ADDENDUM # 001

**Our Lady of Fatima
545 Baldoon Rd
Chatham, ON**

**General Renovations and Addition for Mechanical
Equipment
Phase III**

Project No. 619-CP1902

Drawn	BMD	Date	03/01/2019
Checked	JDF	Project No.	8586
Approved	JDF	Drawing No.	MR-1
Scale	1:100

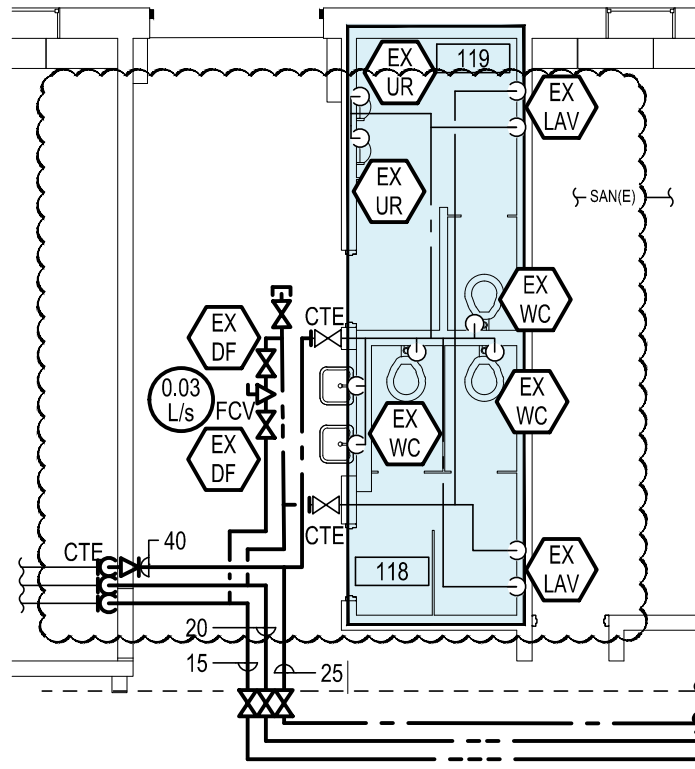
1. Refer to revision drawing MR-1, attached.

REVISION TO DRAWING M101

DRAWING REFERENCE	MANUFACTURER	MODEL	STATIC DEFLECTION (MM)	REMARKS
FC-502	VIBRO	SCSR-2AH	50	MINIMUM SIX UNITS - HOT DIPPED GALVANIZED 150mm THICK CONCRETE INERTIA BASE (USE VIBRO ENUN2 FLEX CONNECTORS WITH CONTROL RODS) USE FOR PIPING SERVICE CP-302A/B - MINIMUM FIRST 3 HANGER RODS
CP-302A/B	VIBRO	CIB/SIPS/SFS	25	
PIPING	VIBRO	SHB	-

Title	GROUND FLOOR PLAN PLUMBING REVISION		Drawn	BMD	Date	03/01/2019
			Checked	JDF	Project No.	8586
Project	OUR LADY OF FATIMA PHASE 3 RENEWAL THAMES VALLEY DISTRICT SCHOOL BOARD		Approved	JDF	Drawing No.	MR-2
			Scale

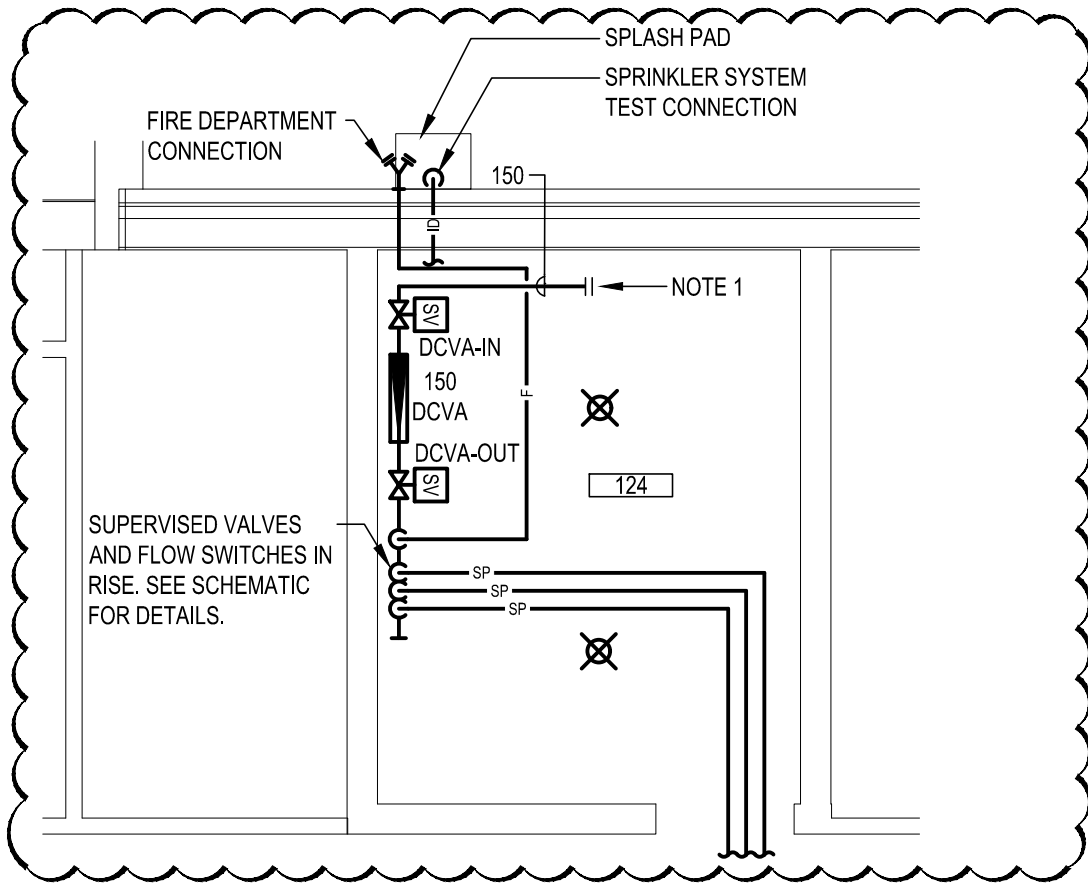
1. Refer to revision drawing MR-2, attached.

REVISION TO DRAWING M201

Drawn	BMD	Date	03/01/2019
Checked	JDF	Project No.	8586
Approved	JDF	Drawing No.	MR-3
Scale

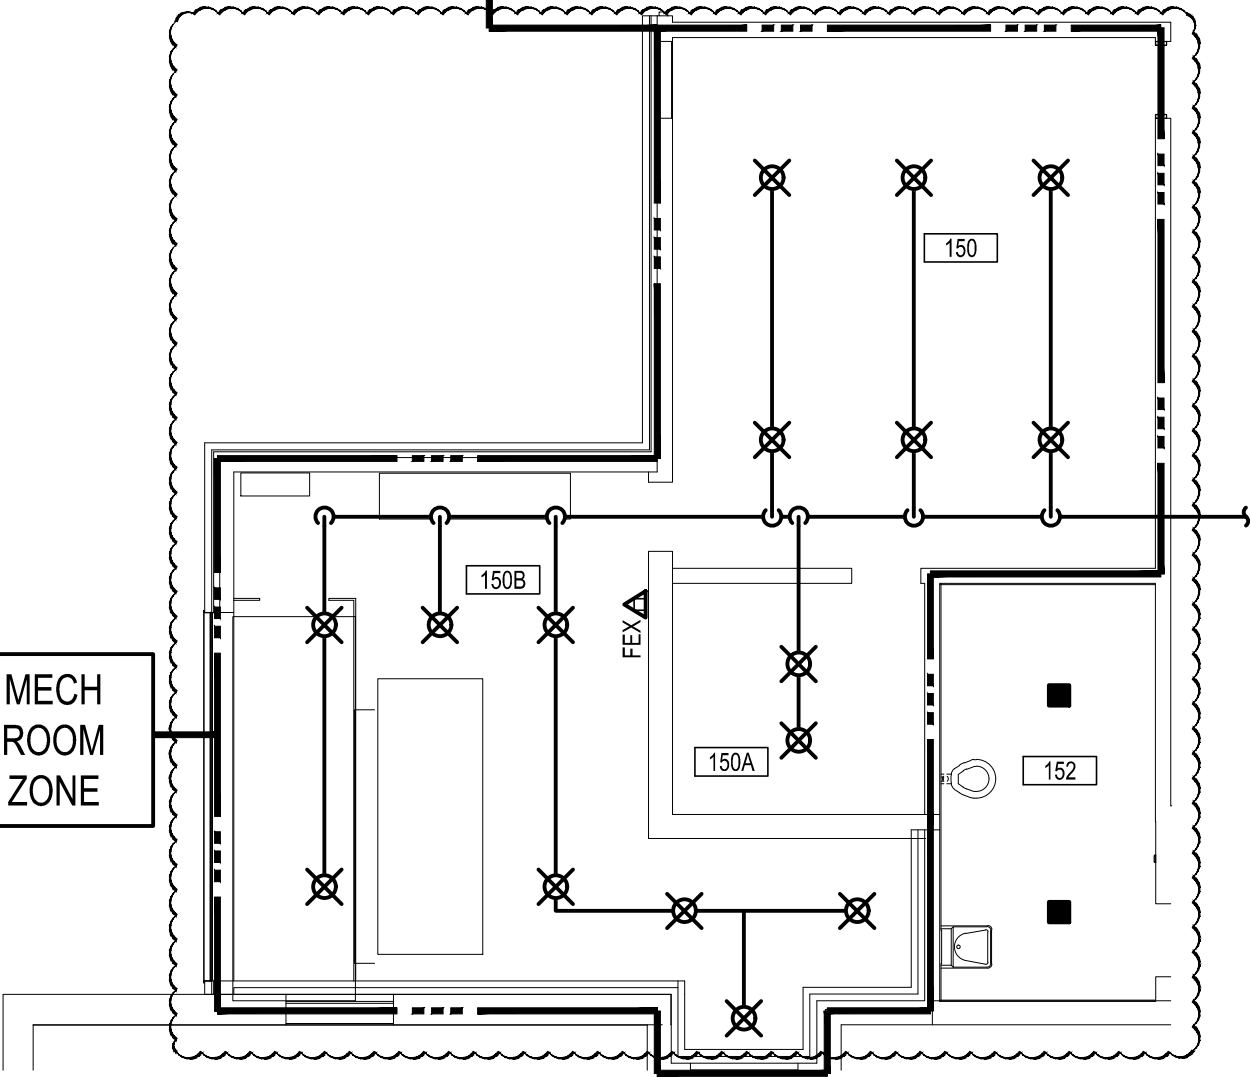
1. Refer to revision drawing MR-3, attached.
2. Refer to revision drawing MR-4, attached.

REVISION TO DRAWING M301

- NOTES:**
- CONNECT TO EXISTING FLANGE.

Title	GROUND FLOOR PLAN FIRE PROTECTION REVISION		Drawn	BMD	Date	03/01/2019
	Project	OUR LADY OF FATIMA PHASE 3 RENEWAL THAMES VALLEY DISTRICT SCHOOL BOARD	Checked	JDF	Project No. 8586	
Approved			JDF	Drawing No.		
Scale				MR-4

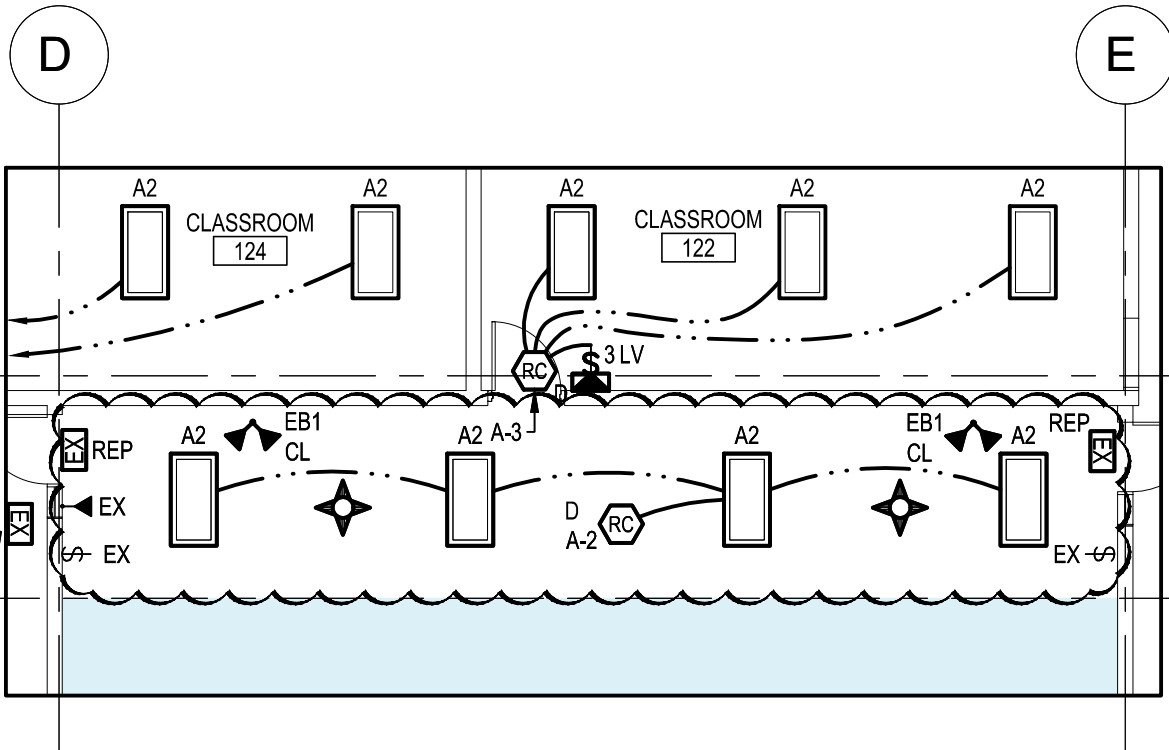
REVISION TO DRAWING M301

Drawn	ZJRL	Date	MAR 2019
Checked	ZJRL	Project No.	8586
Approved	RDZ	Drawing No.	ER-1
Scale	AS NOTED

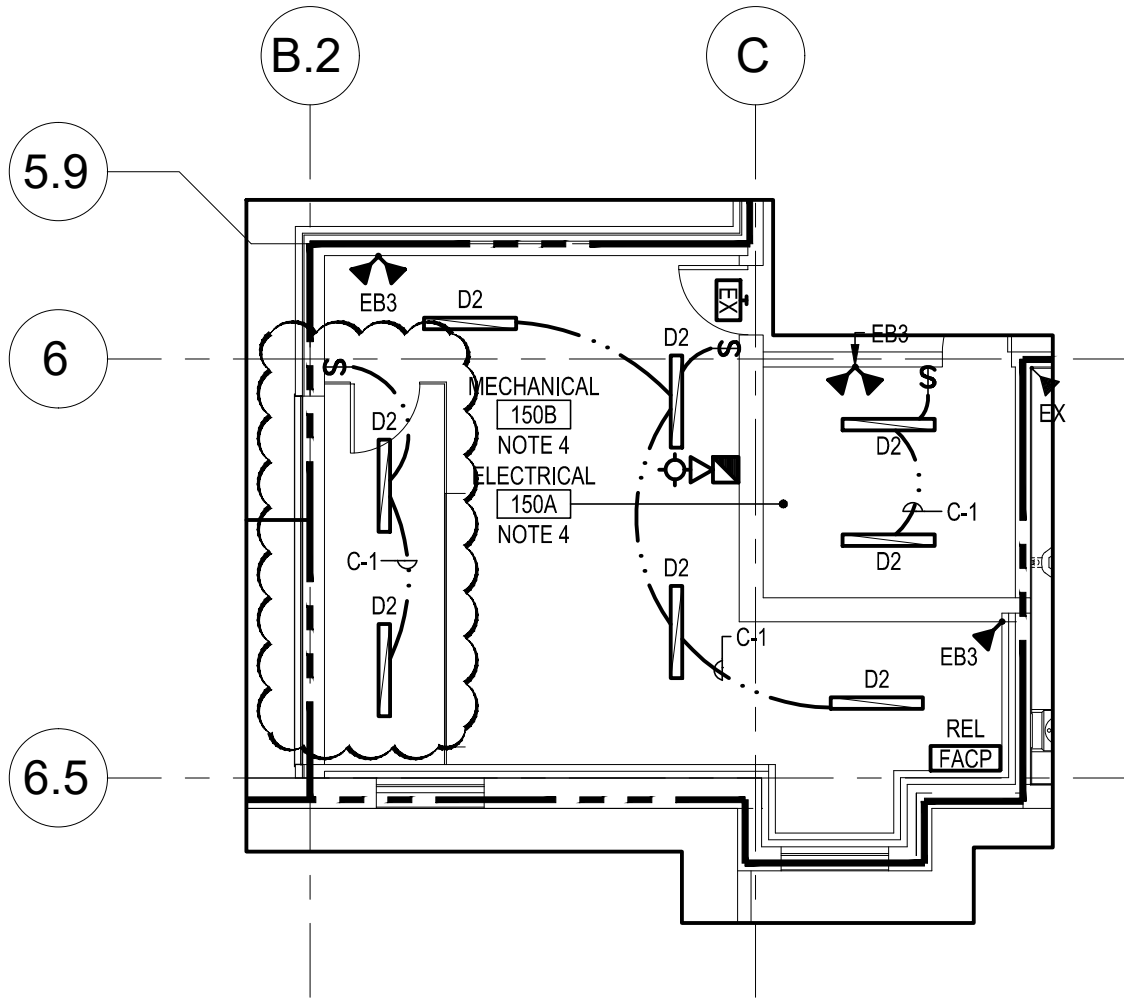
1. Add emergency light remote head to IT (Room 144A). Connect to emergency battery pack in Cust (Room 144).
2. Connect Luminaire Type B2 in IT (Room 144A) to circuit A-2.
3. Provide Room Controller with dimming and input module above Panel A for control of site lighting fixtures connected to circuit A-53. Site lighting to be controlled by the BAS.
4. Provide Room Controller with dimming and input module above Panel E for control of site lighting fixtures connect to circuit E-55. Site lighting to be controlled by the BAS.
5. Complete electrical revisions as indicated on Revision Drawing ER-1 and ER-2 attached.

REVISIONS TO DRAWING E200

Date	MAR 2019
Project No.	8586
Drawing No.	ER-2

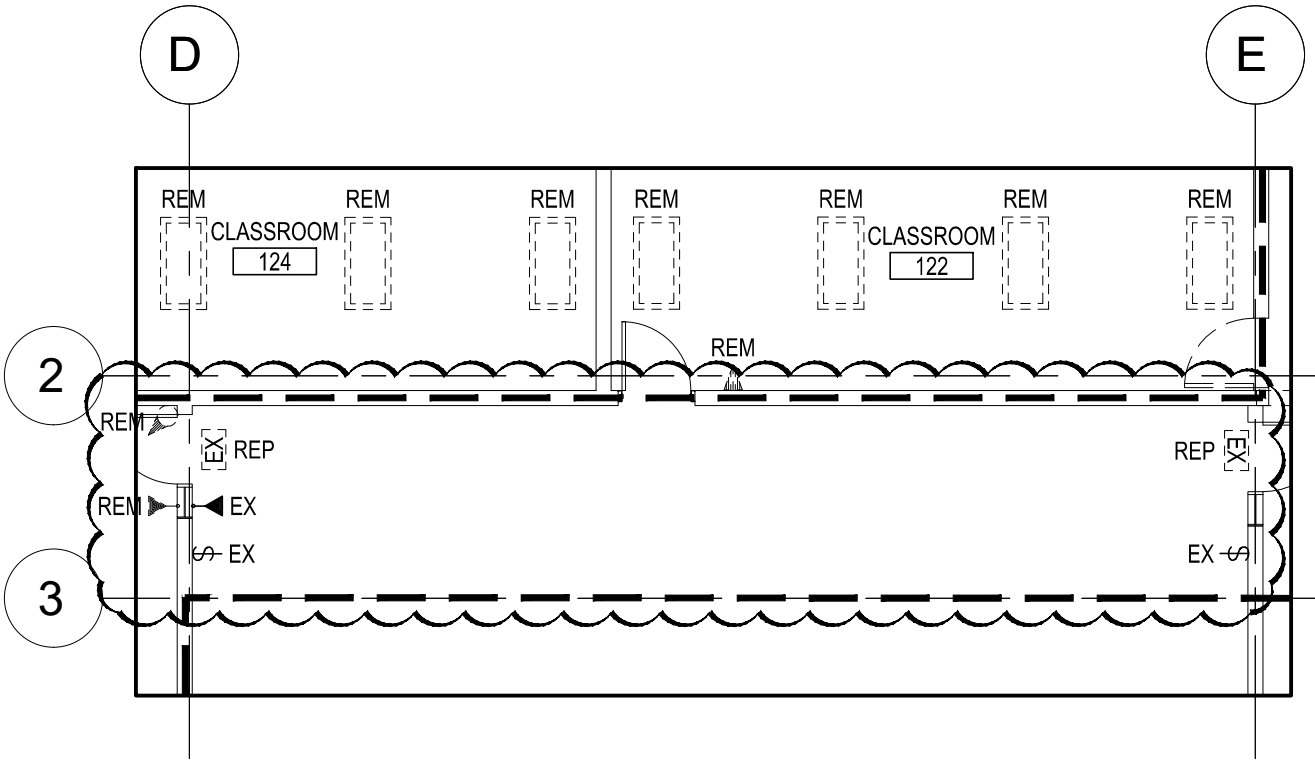
REVISIONS TO DRAWING E200

Date	MAR 2019
Project No.	8586
Drawing No.	ER-3

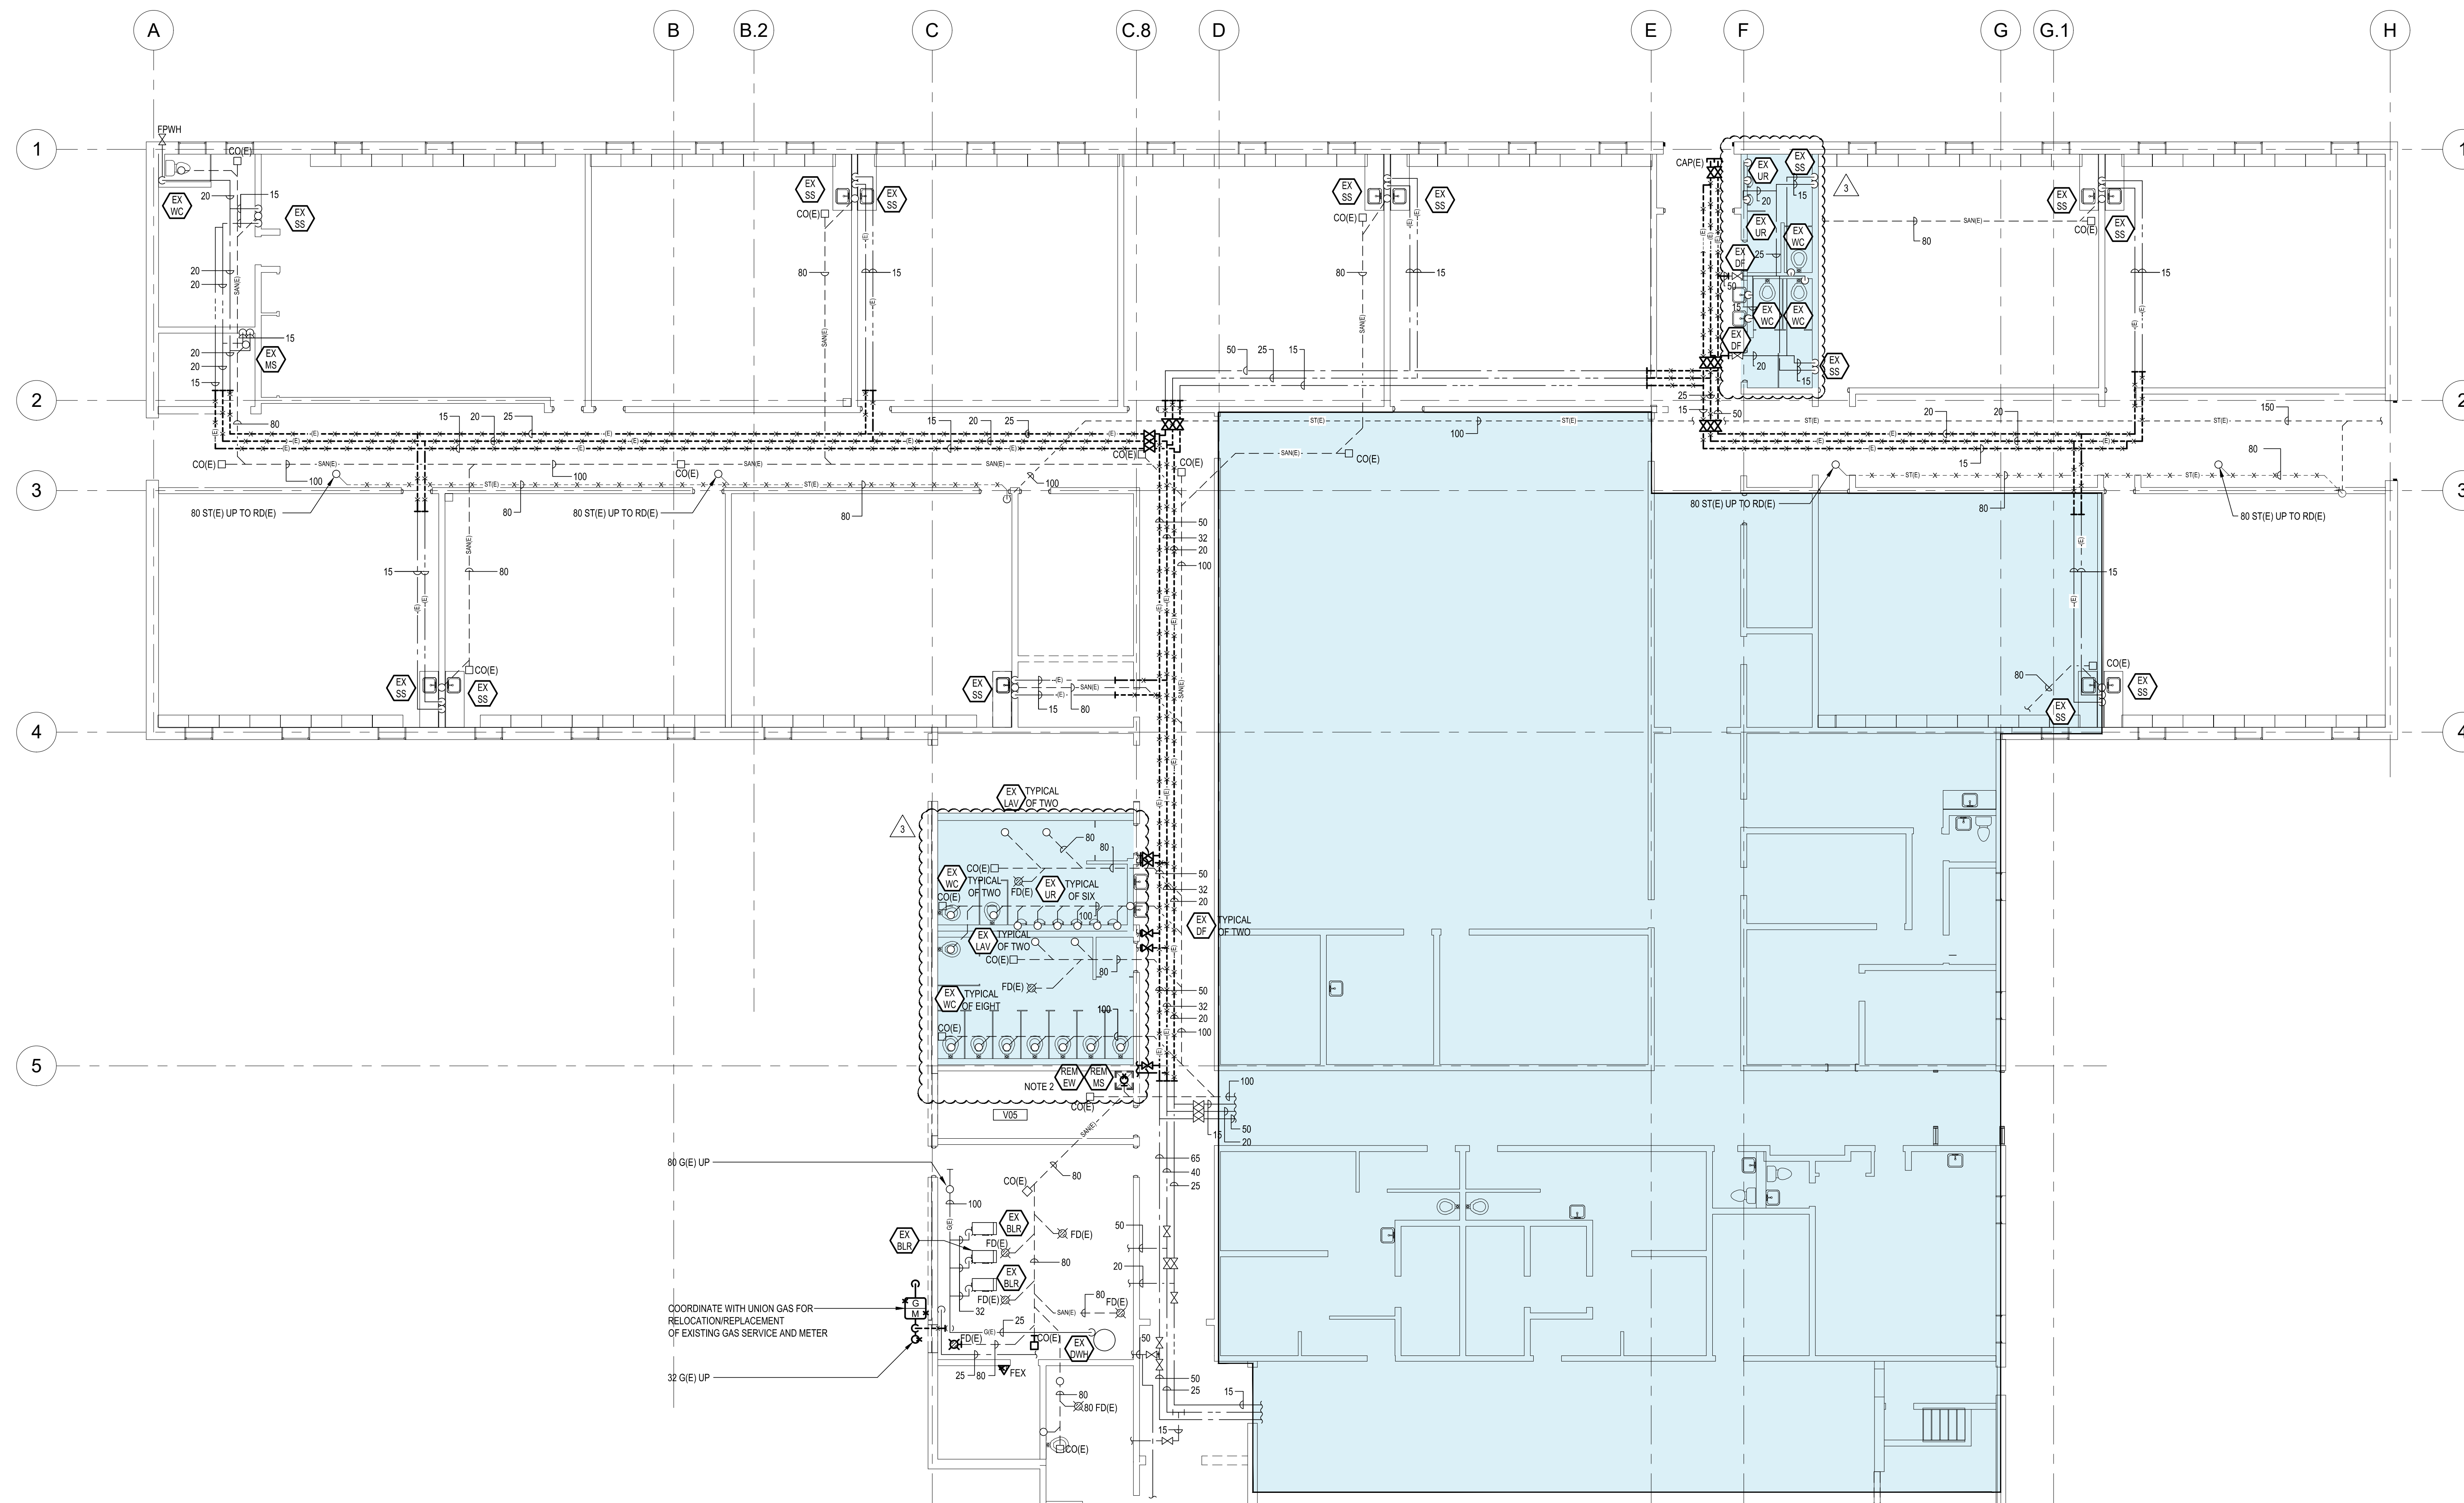
1. Revise Note 4 to read: "...Unless otherwise noted, completely remove and reinstall all ceiling mounted lighting and fire alarm devices within the outlined area as required for sprinkler piping installation. Coordinate with sprinkler contractor."
2. Remove site lighting relays, contactors and time clocks made redundant by this phase. Remove all associated wiring and conduit back to source.
3. Complete electrical revisions as indicated on Revision Drawing ER-3 attached.

REVISIONS TO DRAWING E400
